**Comments on AFS (GRE/2001/14, 15 and 16)**  
**Transmitted by the expert from Japan**

**AMENDMENT for ECE R.48 (GRE/2001/15)**

<Example 1>

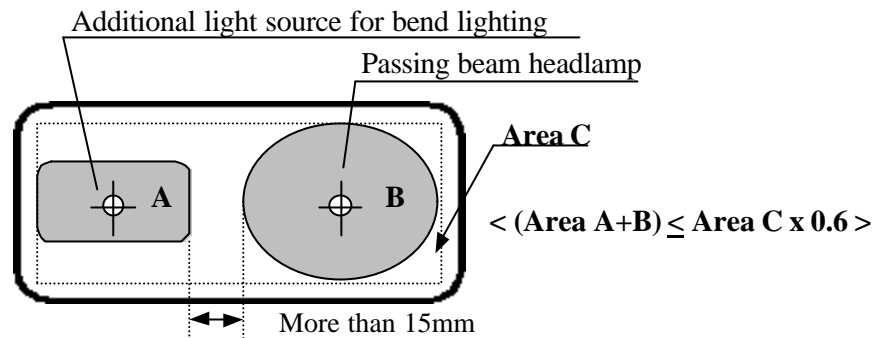
Definition of a single lamp for lighting functions should be established separately from that of light signalling functions. In this case, the hypothetical design layouts as shown in example 1 and 2 both having a common built-in outer lens for the passing beam headlamp and the additional light source should be considered as a single lamp.

If the recently proposed definition (60% area or 15mm) by WP29/2001/8, that is originally meant for light-signalling functions, is to be applied also to lighting functions, that will place a tremendous restriction on manufacturer’s freedom to design.

**2.16.2. “A single lamp” means a device or part of a device having one lighting function, one or more light source(s) and one apparent surface in the direction of the reference axis which may be a continuous surface or composed of 2 or more distinct parts, meeting the requirements below.**

**For the purpose of bend lighting, additional light source in the headlamp assembly can be considered as a part of the above defined apparent surface.**
